Rhode Island Airport Corporation

**ADDENDUM NO. 001
INVITATION FOR BID NO. 26559
Application of Tennant Floor System to Concrete Aviation Hangar Floor
Quonset Airport, North Kingstown, RI**

TYPICAL CONCRETE SLAB DETAIL THROUGHOUT

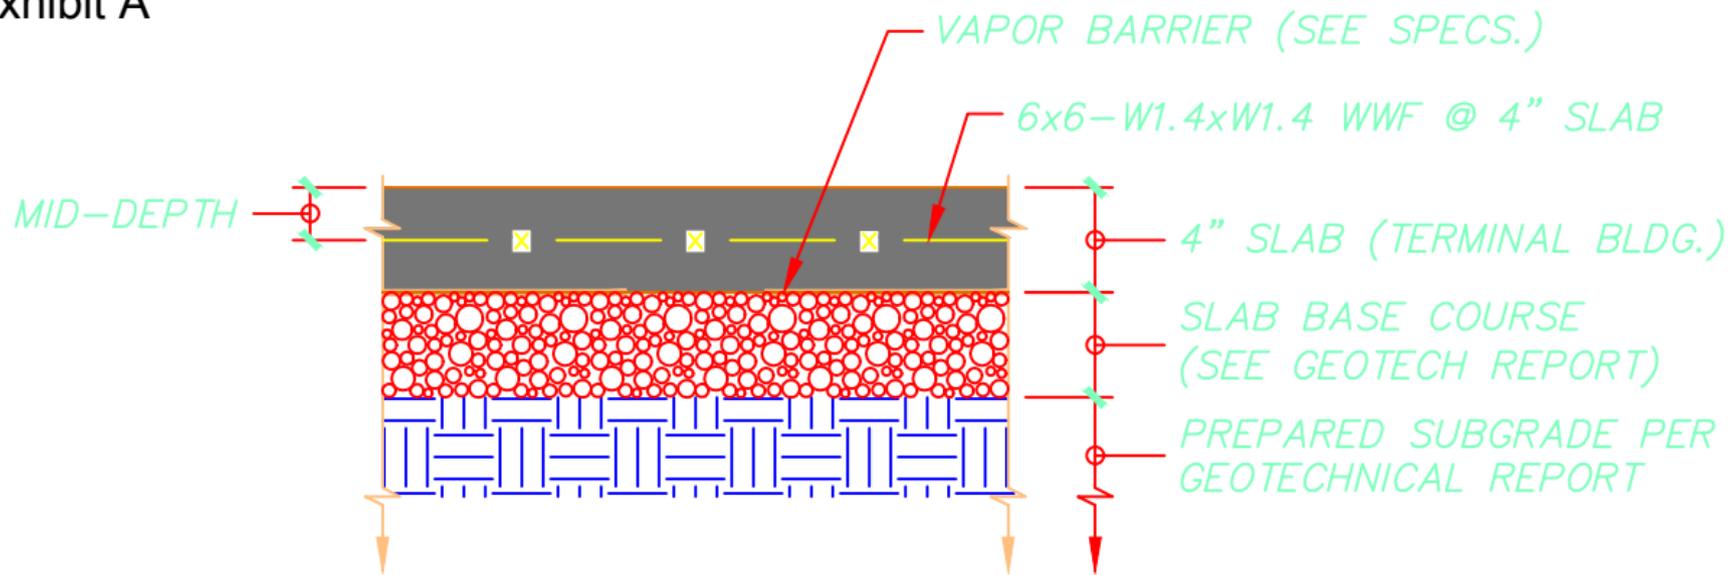
1. Please note the following change in dates:
Due date for bids is no later than 10:00AM EDT September 26, 2016, at which time they will be publicly opened.
2. **Hangar Floor plans are in Exhibit D attached.**
3. There is a Hangar Flood Protection Barrier wall within the Hangar. The floor bolts for the existing barrier must be protected/removed/replaced during flooring project.
Please see Exhibit B and C for the Hangar Flood Protection Barrier location and details.
4. Is there a vapor barrier under the slab?
Yes. Please see Exhibit A attached.
5. Please ADD the following Section:
